Rule 34 Registration Mad Cow & Containments Section 12, T24S, R30E, Eddy County

Volume 2 In-Ground Containment Modification

RE: Vaughan Operating, LLC, Mad Cow Recycling Facility & Containments Permit Number 2RF-207, Facility ID fVV2426951124, Rule 34 Produced Water Containments, Section 12 T24S R30E, Eddy County

NORTH - SOUTH PROFILE

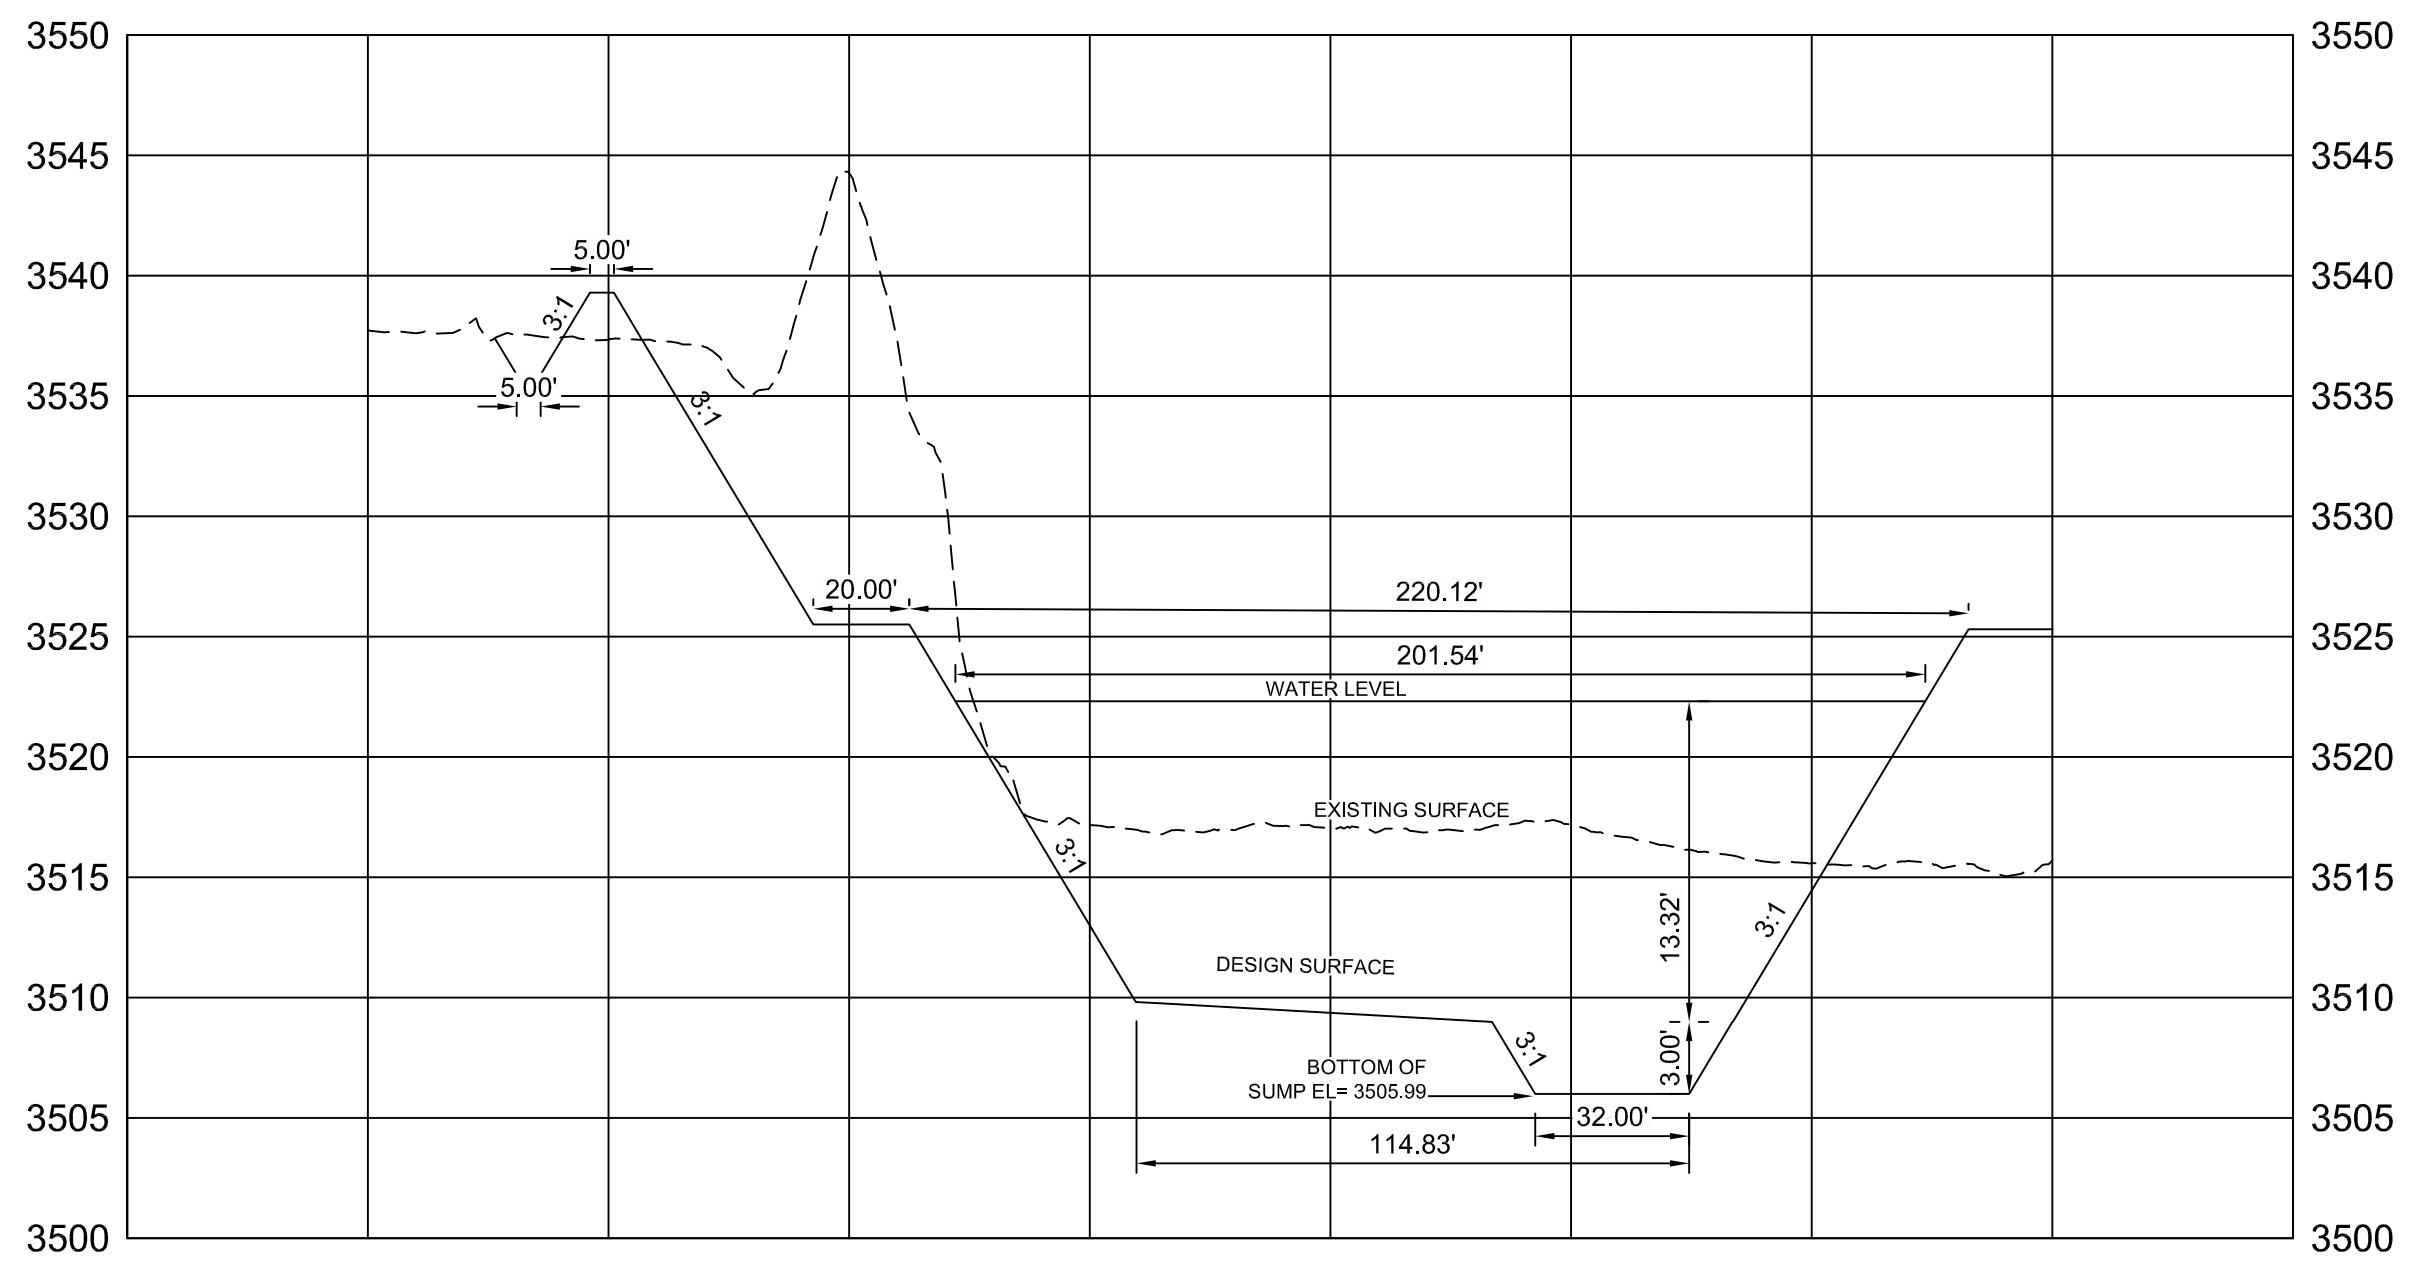
REVISIONS
No. DATE DESCRIPTION
10/10/24 WEST PONDS COMBINED
